No: 000302

CHRISTEN INDUSTRIES, INC.
1048 SANTA ANA VALLEY ROAD
HOLLISTER, CALIFORNIA 95023
TELEPHONE: (408) 637-7405

U
S
TSubject: REVISION OF FUSELAGE AND
CANOPY AFT HINGE MODIFI-
CATION PROCEDURE IN
PRODUCT LETTER 000295

Engineering Sketch X-90136, Rev. C

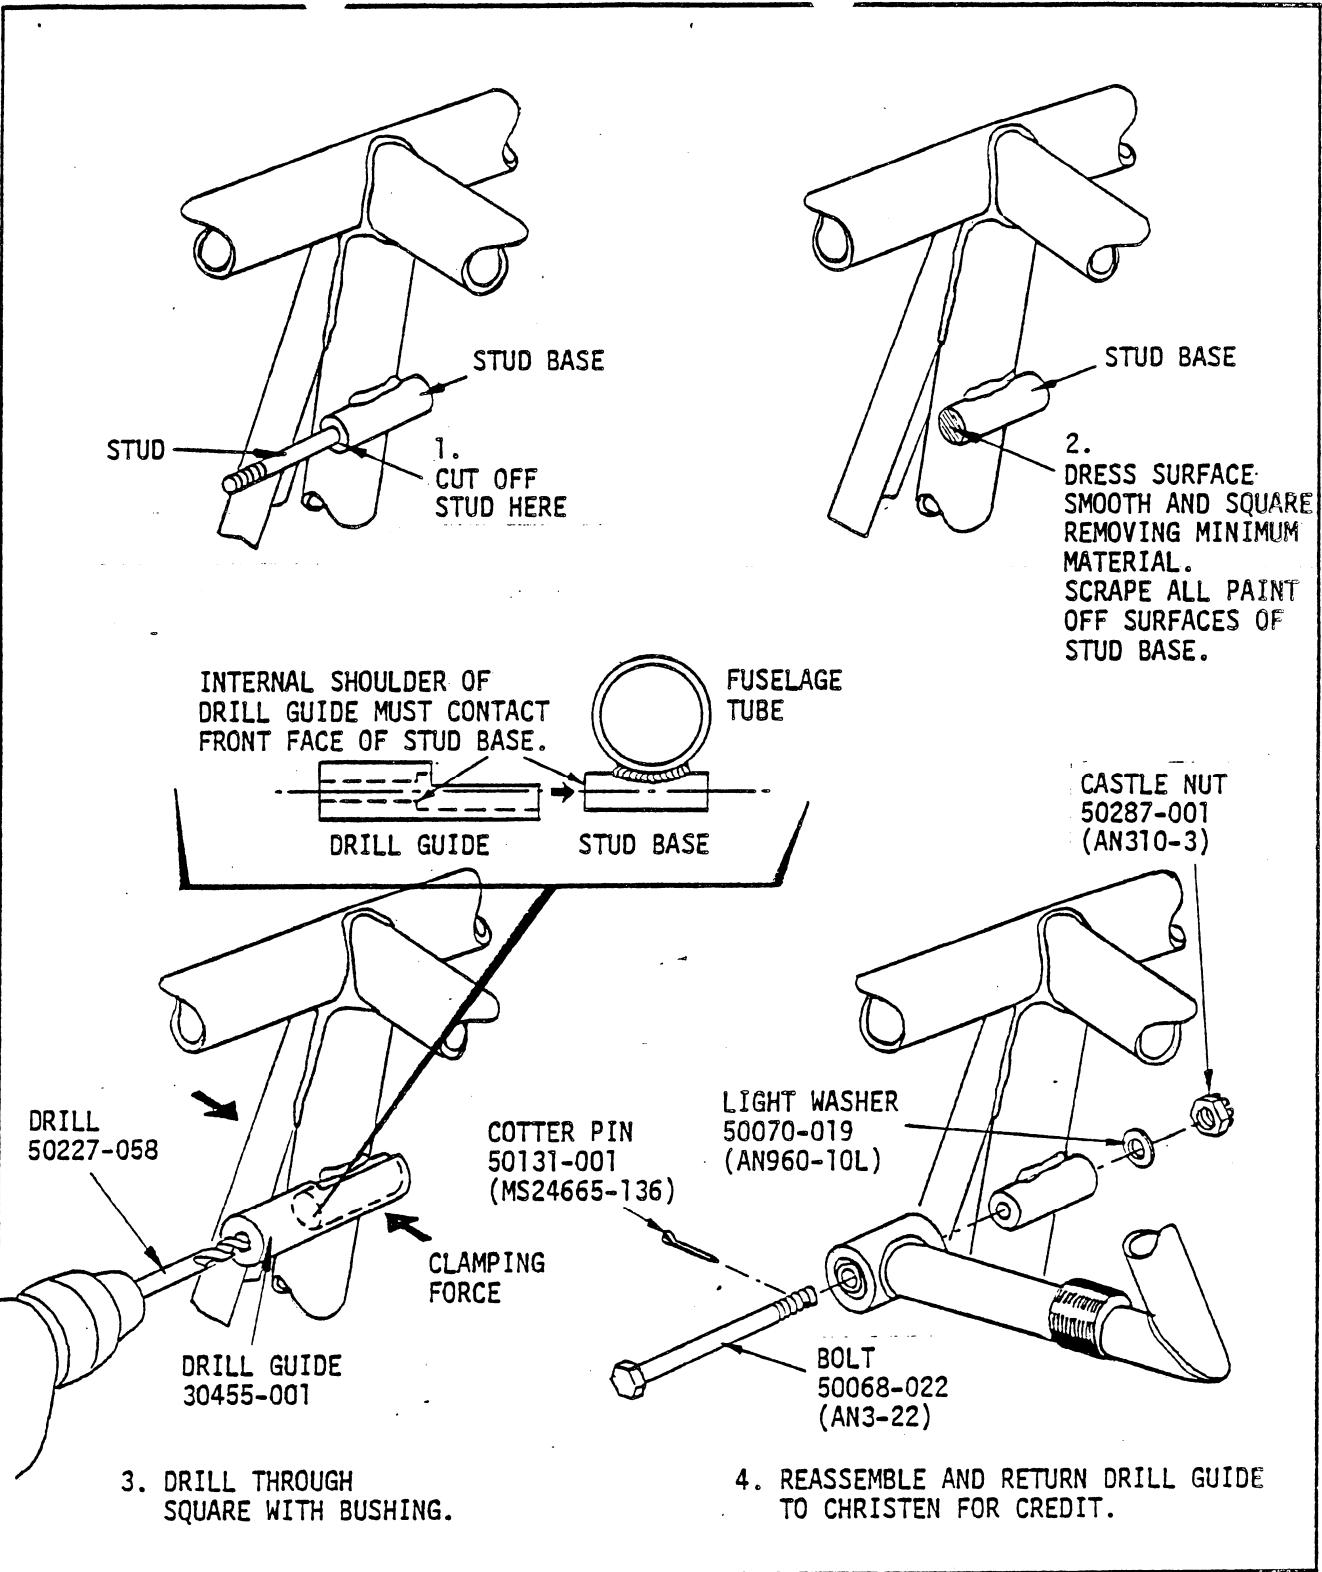
When modifying the canopy aft hinge stud in accordance with the procedure in the subject product letter, several builders have found that the resulting drilled hole was not parallel to the axis of the hinge stud base. This resulted from not having the drill guide installed properly prior to drilling due to the presence of paint on the stud base. The instruction procedure did not account for the possible requirement to remove paint to ensure proper positioning of the drill guide. The procedure has been modified as follows and a copy of Revision C of Engineering Sketch X-90136 is attached.

For modification, refer to Engineering Sketch X-90136 and to Step D-2 of the 915 Canopy Kit product manual:

4. With a fine-blade hacksaw, carefully cut off the canopy hinge support stud at its shoulder without removing any material from the shoulder. File away any remaining stud portion smooth and flush with the shoulder, removing a minimum of material from the shoulder.

5. Scrape all paint off all surfaces of the stud base.
6. Slide the 30455-001 drill guide over the stud base toward the rear of the fuselage UNTIL THE INTERNAL SHOULDER OF THE GUIDE IS AGAINST THE FRONT FACE OF THE STUD BASE. Clamp the guide in position with a small C-clamp.

7. Using the drill guide, carefully drill through the center of the stud base with the 50227-058 (3/16" dia) drill. To ensure a straight and parallel hole, hold the drill without lateral or twisting forces on the sides of the drill guide. Apply and release drilling force alternately to clear drill cuttings. Use a lubricating or cutting oil on the drill while drilling.

8. Clean, prime, and repaint the stud base, as appropriate.
9. If the canopy was installed previously, reinstall it using the 50068-022 bolt, 50070-019 washer, and 50287-001 castle nut for the rear hinge

attachment. Tighten the nut securely to seat all bearing parts, then loosen the nut slightly to allow free rotary bearing movement with moderate drag but with no axial play.

10. Secure the castle nut in its adjusted position with the 50131-001 cotter pin. Clinch the prongs of the cotter pin if the aircraft has been completed (through 923 Kit), or spread the prongs only slightly to keep the pin in position, but to allow removal later during remaining construction.
11. Reinstall all rear seat and canopy components as appropriate.
